MFN 06-262
Supplement 4

Subject: **Modified Reactor Building/Fuel Building Truncated Model,
SER-ESB-038 Rev. 5**

**Shimizu Engineering Report SER-ESB-038, Rev. 5,
“Modified RBFB Truncated FE Model Analysis Data,”**

Project	General Electric Company ESBWR Project	Shimizu Document No.	SER-ESB-038
Title	Modified RBFB Truncated FE Model Analysis Data	Rev.	5
		Issued Date	9/22/06
		Revised Date	1/9/07

Figure C-27 Element Forces Comparison NASTRAN to ANSYS (RPV Pedestal: Out-of-plane Shear [MN/m])

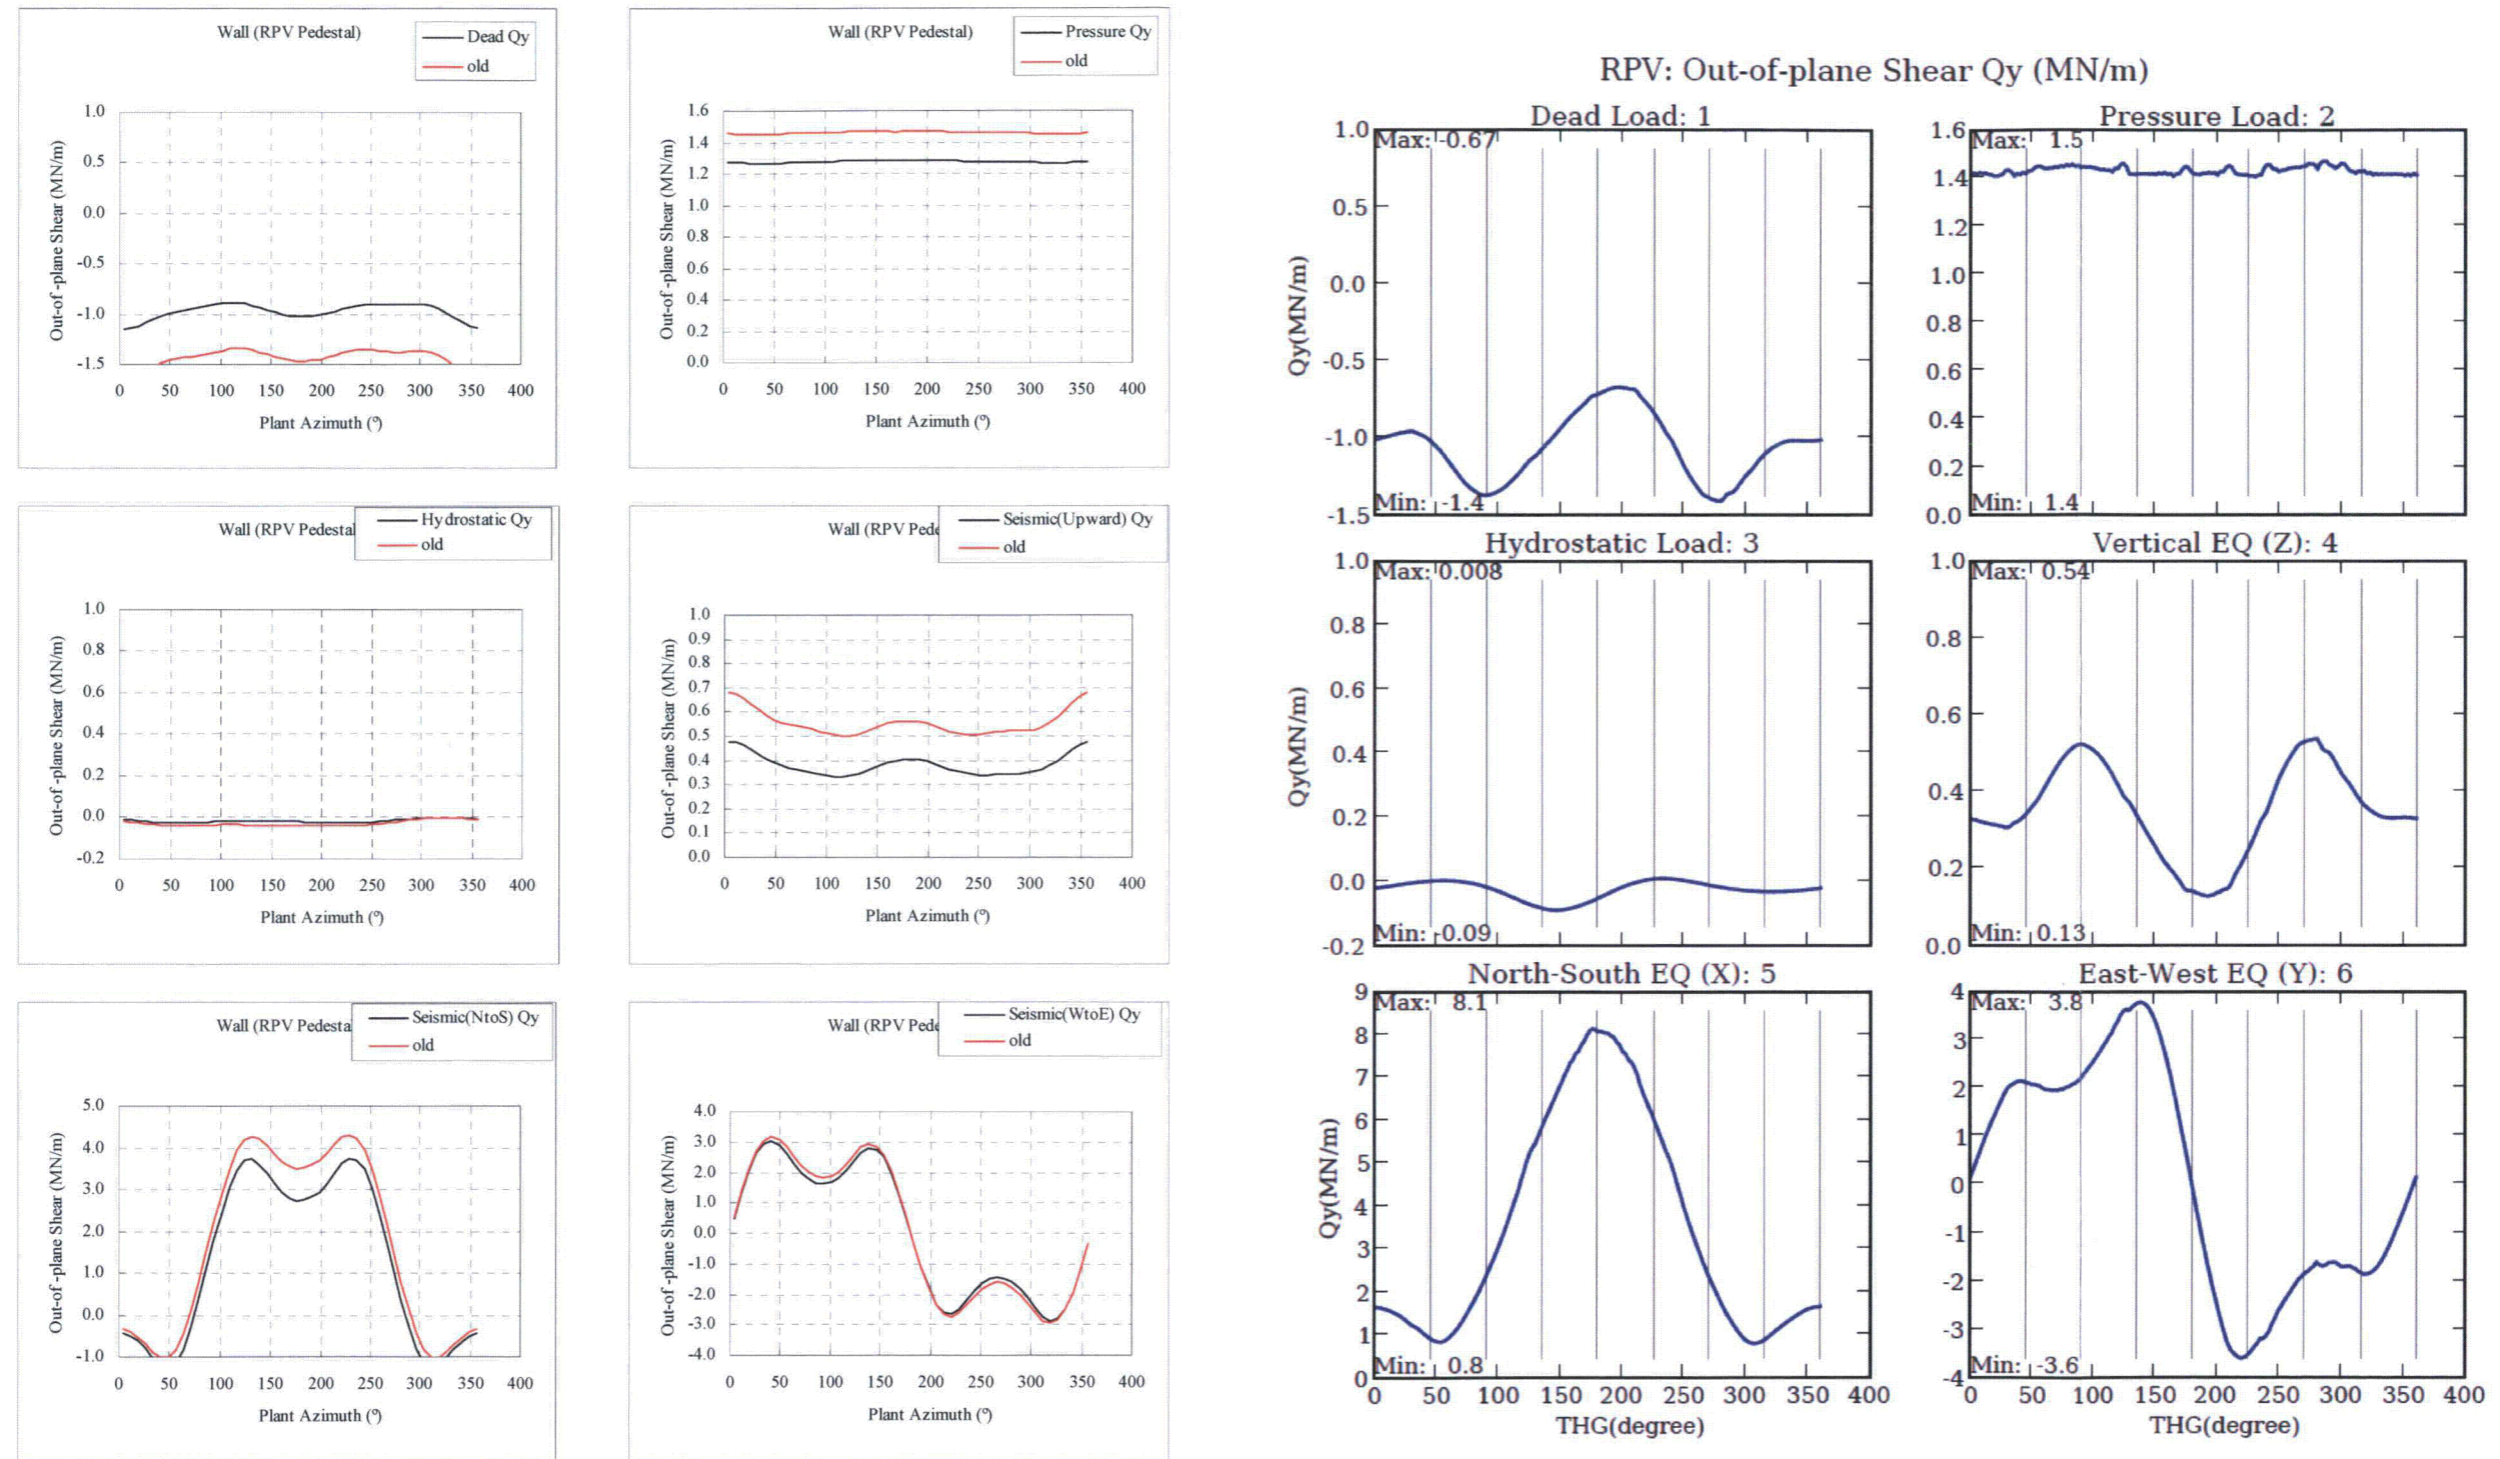
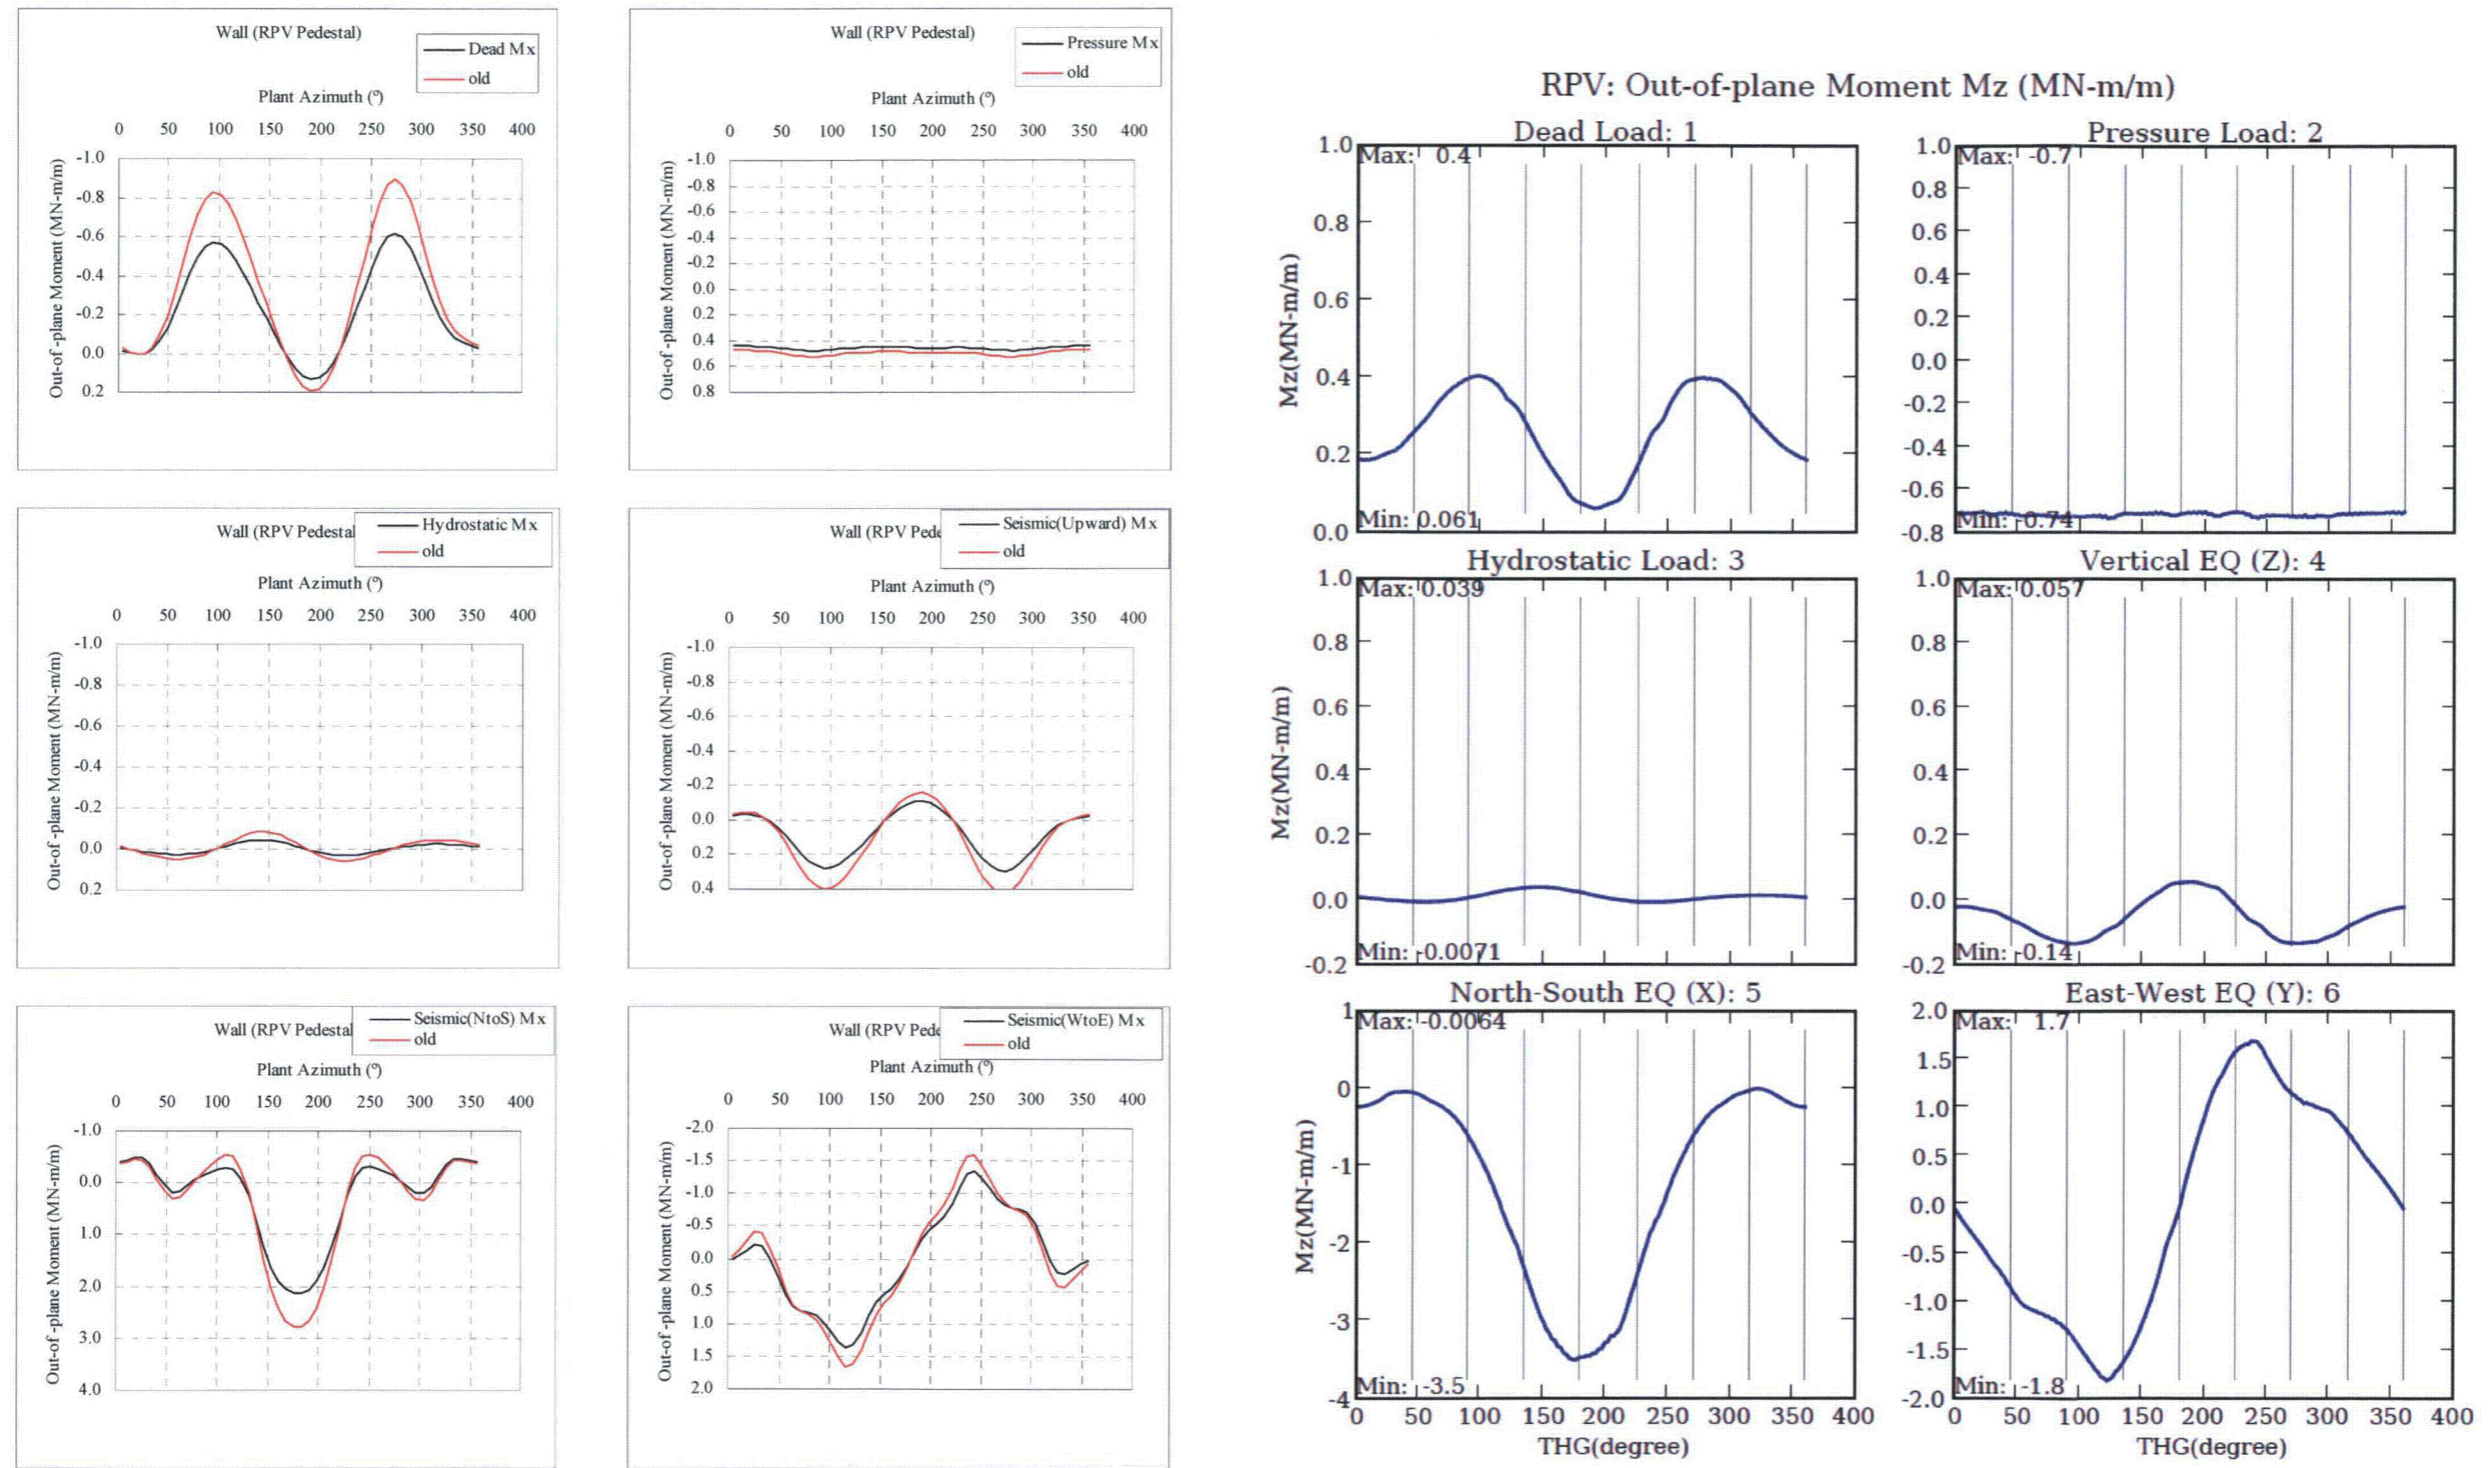
- iii) *The differences of magnitude of forces appeared on basemat inside pedestal:* The result of re-analysis using the updated model shows better agreement. In case of seismic load the magnitude of forces has to be re-compared because BNL's soil spring may not be adequate as pointed out above 3).

- iv) *The differences of magnitude of forces appeared on outer wall of Fuel Storage Pool (FSP):* For the out-of-plane shear forces and moments on RA and F3 wall located around FSP in case of Hydrostatic load, BNL's results are lower than those of GE. GE assumes the some part of differences comes from the difference of estimation levels between both models as pointed out above 8). In order to have a better understanding of the differences, GE would like to request BNL to confirm the input data for Hydrostatic load.
